SEWAGE DISPOSAL SYSTEM

A REPAIR

SUBDIVISION _____ ROAD 14102 Monticello Drive LOT 3

P 36147
Repair

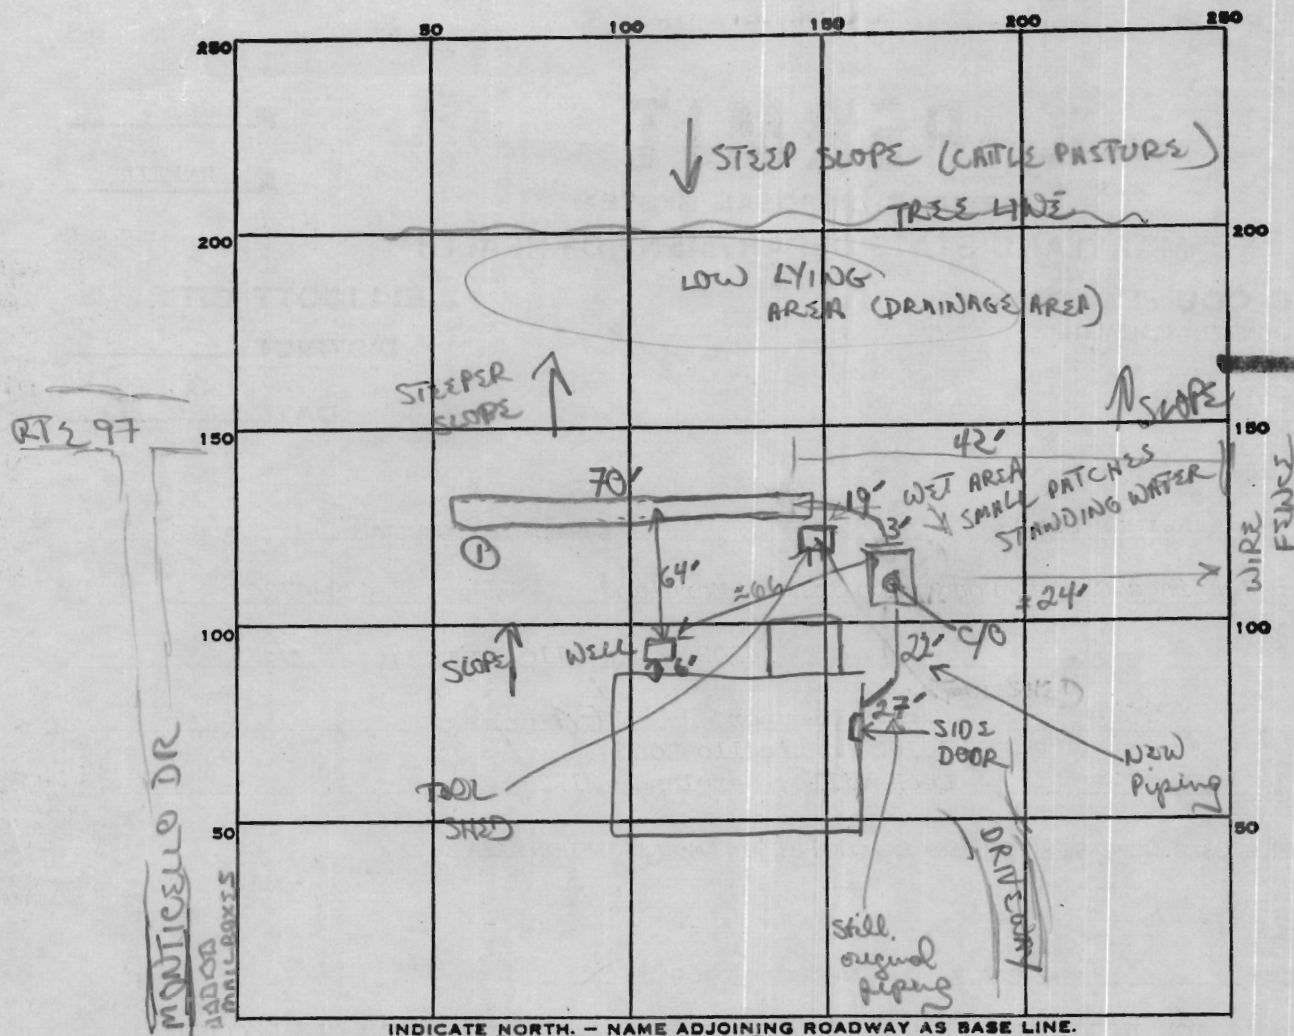
REMARKS 11/18/85 SOIL MOSTLY SANDY LOAM; APPEARS TO BE SOME MOTILED SOIL AT
BEGINNING OF TRENCH (ALSO AREA WHERE PATCHES OF 420 PRESENT), WILL DISCOVER
OLD TRENCH PIPE. TRENCH TO BE AT LEAST 60', IF MORE GOOD SOIL MAY
EXTEND A LITTLE FURTHER. WILL GIVE MIN. 480 SQ. FT. (#160/BEDROOM)
LOCATION OF TRENCH IS BEST FOR SITUATION AND ABOUT SAME DISTANCE FROM WELL
AS ORIGINAL AREA.

Had to install new S.T. Cold one metal had rotted through
OK to cover trench & all work.
